Access Compliance Report

Public Rights-of-Way

Intersection ID: N/A	Main Street: CROSS POINT CIR	Cross Street: NORTHEAST PWY	Location: SE
ADA ID: F54117468F99	Ramp Type: PerpDiag	Initial Pass/Fail: Fail	Overall Compliance: No
		Severity Score: 50

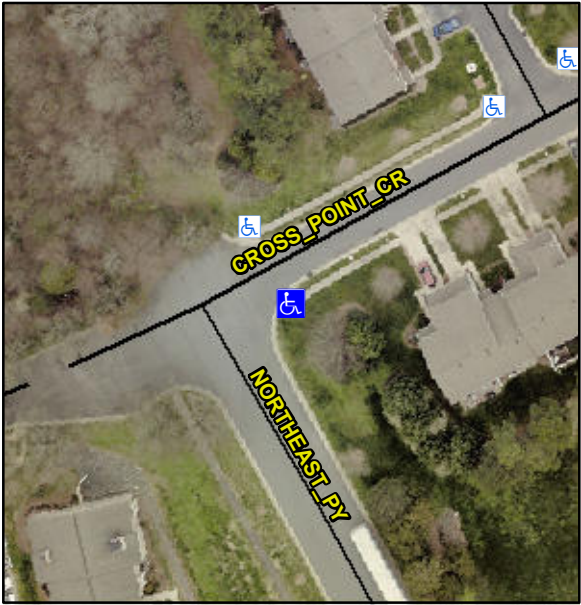
Codes/Mitigation Info/Possible Solution			Field Measurements/Component Compliance			
	Possible Solutions:		Compliance	Description	Data	
	Remove & Replace Curb Ramp With Two New Directional Ramps or Equivalent.		N/A	Ramp Length (in)	62.0	No
			Yes	Ramp Width (in)	48.0	No
			N/A	Flare Type LT	N/A	N/A
			N/A	Flare Slope LT (%)	N/A	N/A
			N/A	Flare Traversable LT?	No	N/A
			N/A	Landing Length (in)	N/A	N/A
			N/A	Landing Width (in)	N/A	N/A
			N/A	Landing Slope (%)	N/A	N/A
			N/A	Landing X Slope (%)	N/A	N/A
			N/A	Landing Curb? (Y/N)	N/A	N/A
			N/A	Shared Landing?	N/A	
			N/A	Gutter Ponding?	N/A	N/A
			N/A	Gutter Lip Ht (in)	N/A	N/A
			N/A	Painted X Walk1?	No	N/A
				X Walk 1 Direction	To N	To W
			N/A	X Walk 1 Width (in)	N/A	N/A
				X Walk 1 Slope (%)	1.2	
				X Walk 1 X Slope (%)	8.1	
			N/A	Ramp inside XWalk1?	N/A	N/A
<p>Surveyor Notes:</p> <p>N/A</p>				Road Slope (%)	7.5	N/A
				Road X Slope (%)	2.5	N/A
<p>PROW/ADA:</p> <p>Not Found, R304.2.2, R304.5.3</p>			N/A	Any Obstructions?	N/A	N/A
